Minutes of the Regular Meeting of the Public Building and Site Commission held on Tuesday, September 26, 2017 at the Reed Intermediate School. Chairman Robert Mitchell called the meeting to order at 7:02 p.m.

### **Change Order Review**

**Monthly Report  
to the Public Building and Site Commission  
September 26, 2017**

RFI 084

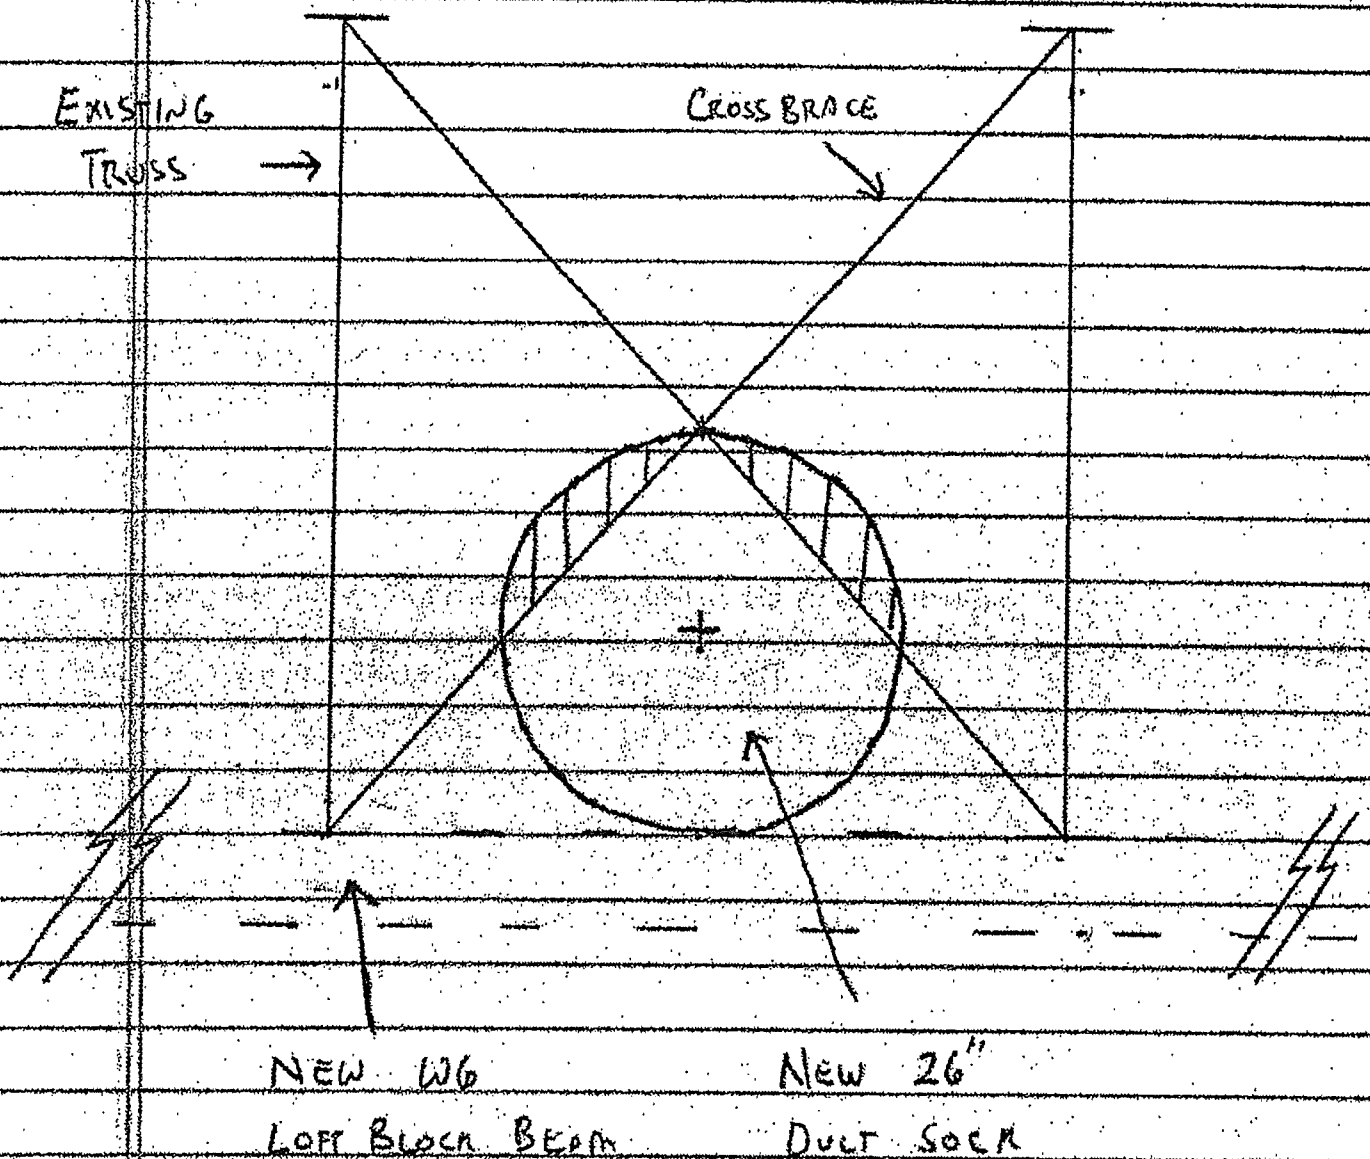
Removal of joist tails in way of rigging steel, Remove X bracing at existing truss to facilitate duct work

# TYPICAL PLAN

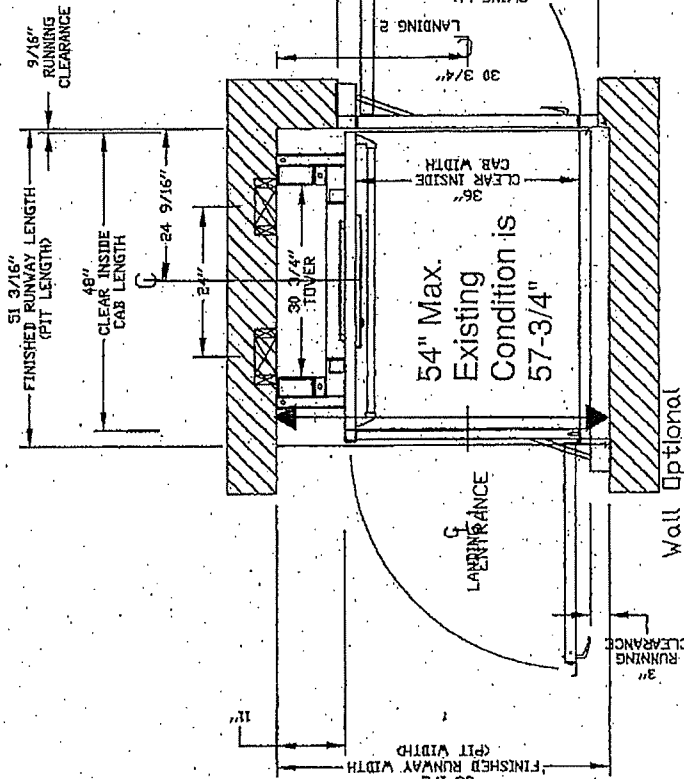
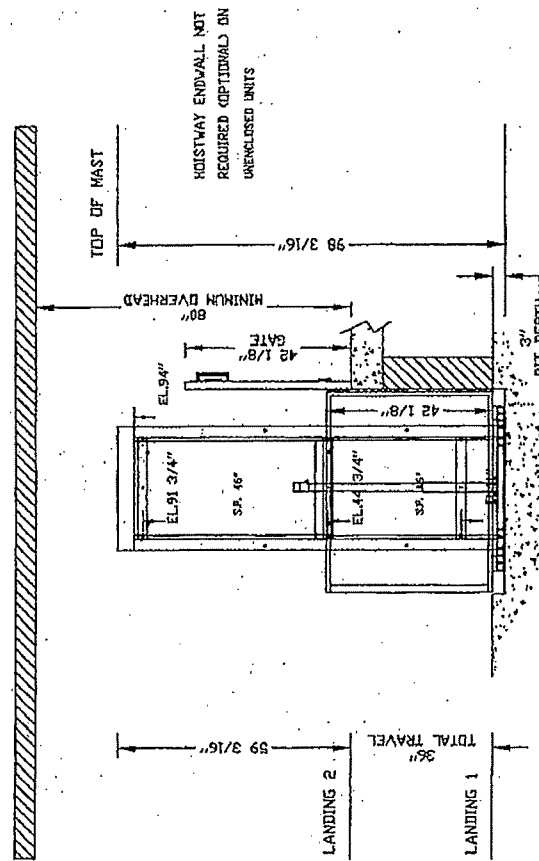
Infill wall at wheelchait lift per RFI 87
